REMARKS

US Patent Application
Title: Electrical Actuator Having Direct Current Motor
(as amended)
WELSH & KATZ, LTD.
Docket No. 9310-94061 Marked-up Sheet 1 of 1

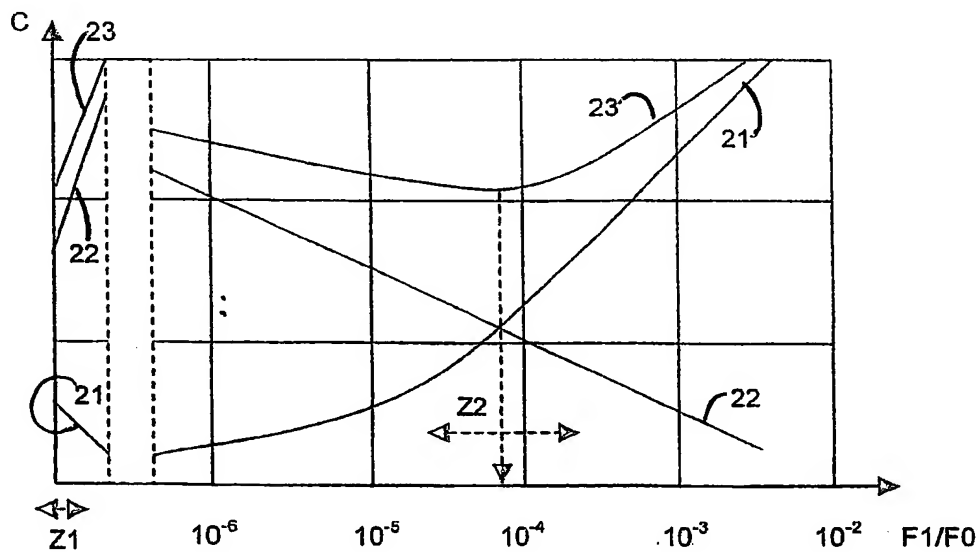
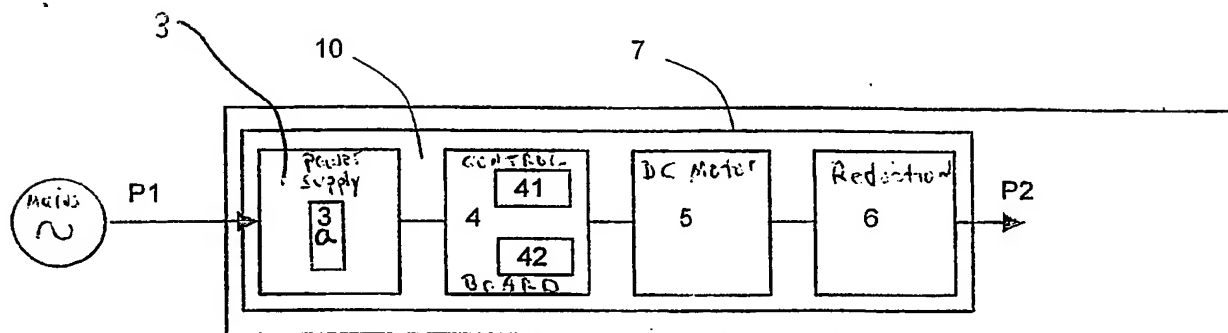
Applicant notes the Examiner's objection to the informal drawings and attaches a replacement sheet herewith. The specification clearly indicates that the converter is designated by reference numeral 3. The term AC/DC converter is used interchangeably with the term "power supply," "power supply unit," and "converter," and is designated by reference numeral 3. The controlled switch 3a is part of the converter. Graph lines 21, 22 and 23 have been shown more definitely, and are fully supported in the specification. No new matter has been added. It is believed that these changes along with the changes shown in the substitute specification will overcome the Examiner's objections to the drawings.

Please amend the drawings in accordance with the replacement sheets attached hereto.

Pursuant to 37 C.F.R. 1.121(d) two sets of drawings are included. The first set shows a clean copy of the drawings with all changes incorporated, while the second set shows the changes marked up in red. The clean copy of the drawings has been labeled as "Replacement Sheets."
